Accessibility audit of Riverbank Arts Centre, Newbridge, Co Kildare.

Access Audit (Revision No. 1)

Prepared by:
Eoin O'Herlihy & Patrick Mullins
O'Herlihy Access Consultancy
Guinness Enterprise Centre,
Taylors Lane, Dublin 8.
Tel: 01.415 1285
Fax: 01.410 0985
E: eoin@accessconsultancy.ie
W: www.accessconsultancy.ie

Ref No. 160062

7 Accessibility Review – Lower Ground Floor

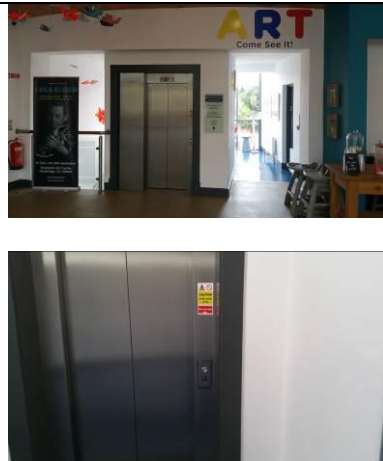
1	External Environment & Approach	The main lower ground floor entrance is to the rear of the building and is accessed through the shared car park via Main Street. This access route is for staff only and access to members of the public is via the upper ground floor only.		Ensure that accessible access routes to the main entrance are easily identified and that information re same is included in pre-visitor information.
---	---------------------------------	--	--	--

Pedestrian access is via the public footpath on main street. Access to the car park area is access controlled. Staff members are informed of the key code and there is a call button directly linked to the box office for assistance. The key pad height is 1420mm (1200mm would be the recommended limit) and the height of the assistance buzzer is 1050mm. On exiting there is only a key pad, no push button to exit or call button for assistance which may restrict a person's ability to exit particularly in an emergency. No signage indicating the accessible entry route etc. is provided. The opening force of the gate appeared heavy and it was noted that no closer was fitted to the gate. A clear opening of 1320mm is provided. It was noted that the mag lock for the access control is located on the opening side of the gate at a height of 1820mm and projects approximately 75mm into the access route, this could potentially be a hazard re someone banging their head. The pedestrian access route through the rear car park to the entrance is not clearly defined/line marked and there is a danger that persons with vision impairment could inadvertently walk into a vehicular route. It is noted that the circulation area between the main lower ground floor entrance and the back	   	Consultation with Kildare County Council should also be considered to identify if access can be improved. During any future upgrading works to the lower ground floor access route the following should be considered: • The access control key pad height at the pedestrian gate should be brought within the range identified in TGD Part M 2010 section 1.5.7. • Signage to indicate the location of the accessible public entrance. • The opening force required to operate the gate – the possible inclusion of power assisted opening /closing, push button release or call buzzer for assistance to be fitted on the internal side, and relocating the existing mag lock out of head height range. • A separate pedestrian route should be identified and clearly marked to minimise the danger of persons inadvertently waling into vehicular routes.

stage/performers entrance has been defined with yellow line marking hatching. No kerbing etc. is provided as the area is level with the car park surface. 2 no. columns are located within this hatched space and they have good visual contrast with the background.		
2	Accessible Parking	1 Number accessible parking bay is provided in the rear car park measuring 2.5x4.9m with a 1.2m access zone to the rear and one side only of the designated parking bay. The access symbol is incorporated into the line marking. No high level signage is provided. The designated space is conveniently located next to the main lower ground entrance.		Riverbank Arts Centre should consider, as part of any future upgrading works, bringing the existing designated disabled persons car parking space in line with best practice - in accordance with TGD Part M 2010, section 1.1.5 & diagram 8.
3	Main Lower Ground Floor Entrance	The entrance doors are incorporated into a large glazed portion of the façade and consists of an outward opening door and a half (slave door). The slave door was in the locked position at the time of inspection. The glazed façade directly adjacent has a mirrored effect and no manifestations have been incorporated into the glazed façade and could cause confusion for visually impaired persons. One high level band of etched manifestation exists on the entrance door set itself. The door has not been clearly defined with a visually contrasting material from its surroundings. It is noted that this entrance is for staff only and as such the staff would be familiar with the door location. Adequate clear space is provided at the entrance on the line marked pedestrian route but the surface is uneven		Riverbank Arts Centre should consider, as part of any future upgrading works, the following; • Permanent manifestations to the lower ground floor entrance door and adjacent glazed façade and by providing a high-contrast strip around the entrance door in accordance with TGD Part M 2010 section 1.2.4.1. • Provision of new ironmongery that will allow for opening with one hand without the need to grab or twist – in accordance with TGD Part M 2010 section 1.2.4.2

with different material finishes at this location which may cause a trip hazard or difficulty for wheelchair users. The leading door is manually operated by a twist knob which could cause difficulty for persons of limited dexterity. A pull handle is also provided and both pull handle and knob do not visually contrast with the door. No call bell etc. is provided to assist persons of limited mobility and no signage indicating the location of the accessible entrance is provided. The opening force appeared heavy and had an average reading of 55N – closed position to 30°, and 55N from 30° to 60°. (recommended max should be 30N & 22.5N) A clear opening of 710mm is provided due to the push bar mechanisms interference on entry/exit. A metal strip is provided at the door threshold and appears adequate.		• Signage indicating the location of the location of the accessible public entrance. • Adjust/replace as necessary door closing mechanism ensuring the opening force is in accordance with TGD Part M 2010 section 12.4.2 • The clear width of the entrance door should be increased to be in accordance with TGD Part M 2010 Table 2. Possibly remove the existing door & a half and replace with one larger accessible door.

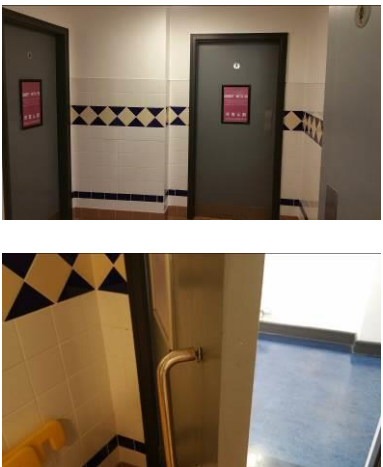
No directional signage indicating stair /lift /WC locations is provided. A door leading from the lobby to a private room was noted - this door was locked at the time of inspection and as this room is not accessible to the public this area was not considered as part of the accessibility audit.		Signage indicating the location of key facilities should be provided. signage should be designed in accordance with TGD Part M 2010 section 1.6.3
5	Main Lower Ground Level Foyer	The area was open and clear of any obstructions at the time of inspection. Lighting was adequate and there was a good visual contrast between walls and floor, and walls and doors. While signage indicating the room access from the foyer was noted, no signage indicating the location of stair/lift/box office was visible. A double door set provided access to the stair and lift. Both doors were operable at the time of inspection and the doors are rebated. Push plates are provided on both doors but no push signage. Both doors have vision panels at a height of 1020 – 2020mm. A clear opening of 800mm is provided via the leading door. The opening force of the leading door appeared heavy – an average reading of 55N – closed position to 30°, and 25N from 30° to 60°. (recommended max should be 30N & 22.5N)		Riverbank Arts Centre should consider, as part of any future upgrading works, the following; - Signage indicating the location of key facilities should be provided. signage should be designed in accordance with TGD Part M 2010 section 1.6.3 - Testing and recalibration of existing door closers ensuring that the opening force are in accordance with TGD Part M 2010 section 1.2.4.2 - The provision of an additional low level vision panel in accordance with TGD Part M Diagram 10.

6	Passenger lift	The following was noted in relation to the design of the lift off the main foyer: No signage, including symbols, indicate the presence of the lift.		Riverbank Arts Centre should consider, as part of any future upgrading works, the following;

• The lift car was 1400mm by 1100mm. • Doors have an effective clear opening of 800mm. • There is poor warning sound indicating the arrival of the lift car although a faint sounder bell can be heard announcing its arrival. • There are no voice announcements within the lift car although an audible bell sounder indicates the arrival of the lift. • A visual indicator is provided on the landings. • A handrail is provided on one wall of the lift car and it has visual contrast with its surrounding. • Controls on the landings do not contrast well with their surroundings and are located approximately 900mm off the ground. • Controls within the lift car were centrally located and have raised numbering indicating the destination but no additional signage is provided. call buttons did not visually contrast with their background. • A half-length mirror is provided. • A clear unobstructed area is provided on the upper ground floor but the clear area on the lower ground floor is reduced to 1500mm by a door swing. • The floor inside the lift car is dark in colour which could cause difficulty for the visually impaired. • An emergency communication call button is provided within the lift car (not tested as part of this audit) • Lift call button on the lower ground floor is located 440mm from the returning wall at a height of 965.		• Signage indicating the provision and location of the passenger lift should be provided to facilitate the finding of the lift. The lift installation should be reviewed to see if it can be upgraded to comply the latest accessibility standards where practicable (e.g. TGD Part M 2010 section 1.3.4.2 and diagram 13).

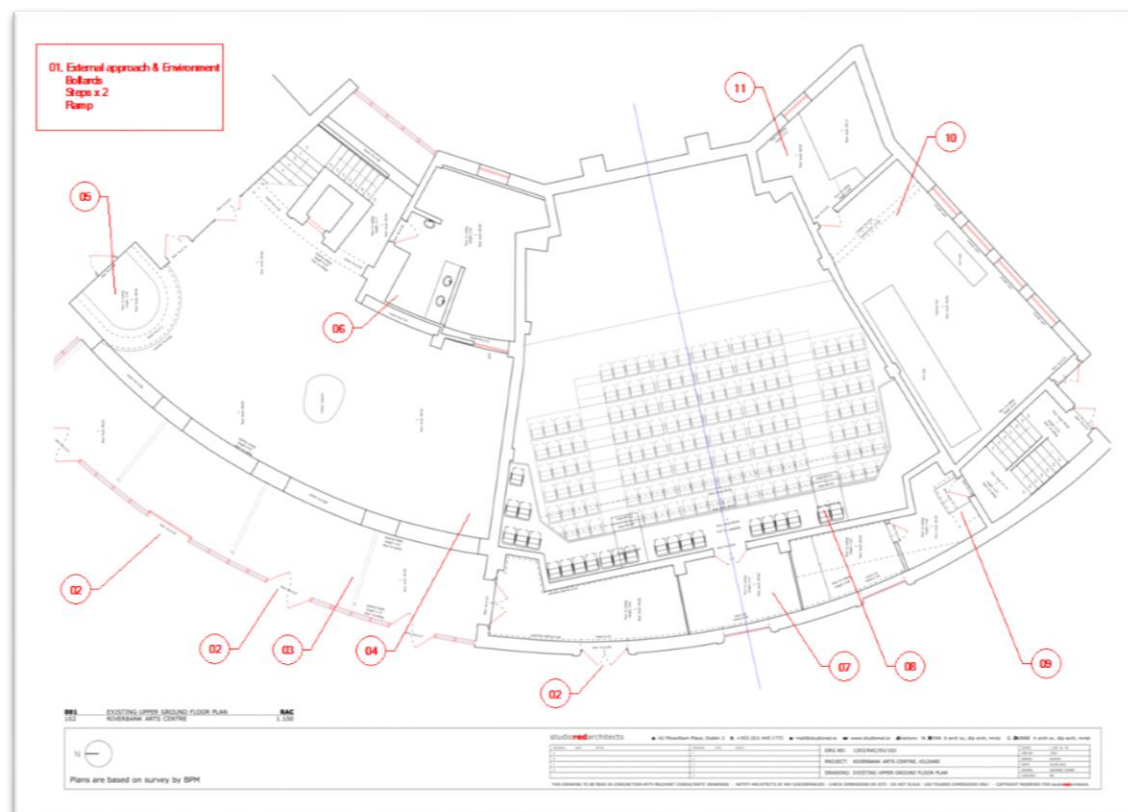
A continuous handrail is provided on the outside/wall side of the stair (except where interrupted with doors) the central handrail is not continuous. Handrails are located 900mm above the pitch line but are not terminated correctly – 300mm extended. Lighting appeared adequate at the time of inspection. It was noted that the ceiling height at the lower ground floor level achieves 2100mm excluding a beam etc. projecting below this level, this could cause a hazard re persons hitting their head. No cautionary signage etc. present. Access from the top 3 flights is to the children's store and the projection room. Neither are accessible to the public and are accessed by authorise personnel only, as such, these areas were not included in the accessibility audit.		
22	Corridor	The corridor is approximately 9,200mm in length and irregular in shape. It narrows to 1170mm at one central location. Approximately 1500 x 1500mm clear space is provided outside the toilets and the dressing room location. The doors on the corridor have good visual contrast with their background and the corridor doors have vision panels located between 800mm and 1800mm in height.		As part of any future upgrading works Riverbank Arts Centre should consider the provision of signage indicating the location of facilities relevant to the area. Signage should be designed in accordance with TGD Part M 2010 section 1.6.3

The floor has good visual contrast with the walls and lighting appeared good. There was no directional signage located within the corridor except for one dressing room tag on the dressing room 2 door.		
23	Staff Toilets	Both toilets are of standard fit out with no additional accessibility fixtures or fittings. The doors open inward and the clear width of both are restricted by the hand drier location behind. Clear opening currently achieved approximately 700 and 742mm. No accessible W/C or adult changing facilities are provided for performers who use wheelchairs or for performers of limited ability. Lighting levels appeared good and there is good visual contrast between the floor and the walls. The visual contrast between sanitary ware and the walls is poor – all white.		As part of any future upgrading works Riverbank Arts Centre should consider upgrading the staff toilet facilities in accordance with best practice for example it may be possible to provide an additional unisex accessible staff/performer W/C in accordance with TGD Part M 2010 section 1.4.5. the provision of adult changing facilities should be considered. The hand dryers should be repositioned maximising the clear opening of the existing doors.

24	Emergency Exit Lobby	The lobby measures approximately 3760mm in length and 1170mm in width (this is further reduced by the radiator location) The internal lobby door is fitted with a vision panel and pull handle and achieves an 870mm clear opening. Vision panels to back stage have been blocked off. The leading edge to the internal lobby door measures 100mm but it is noted that this is marginally improved by the close proximity of the stage door reveal.		As part of any future upgrading works Riverbank Arts Centre should consider increasing the leading edge dimension to the internal lobby door in accordance with best practice guidance give in TGD Part M 2010 section 1.3.3.2. The change in floor level at the back stage door threshold should be provided with a visually contrasting

A threshold of approximately 20mm exists at one of the back stage door and is dark (black) in colour with no visual contrast with the door or any visually contrasting nosing fitted which may cause a trip hazard. A good visual contrast between the remaining walls, floors and doors was noted. The final exit door is controlled by push bar and access control mag lock and a push button release and break glass is provided – signage indicating the requirement to push the door release button is provided. It was noted that some items such as a chair and sweeping brushes etc. were left in the lobby which could cause a hazard if the route was required in an emergency. It was noted that an electrically operated roller shutter door sections off the lighting storage area from the lobby.	 	nosing strip in addition the visual contrast between the door and the floor threshold should be improved.
25	Dressing Room 1	Internally there is virtually no visual contrast between the door and the walls, the door is fitted with a pull handle and achieves 845mm clear opening. No vision panel is provided and the leading edge is 185mm which could cause difficulty for wheelchair users on exiting. A standard shower and wash hand basin is provided with no additional accessibility fixtures and fittings. via a sliding door – The door achieves 670mm clear opening and is fitted with a locking mechanism that is not suitable for persons of limited dexterity and no handle is provided on the outside.		When carrying out retrofits or repairs Riverbank Arts Centre should consider upgrading the dressing room facilities. The provision of at least one dressing room with accessible shower and W/C facility, in accordance with TGD Part M 2010 section 1.4.8, ensuring that performers who use wheelchairs can use the facilities.
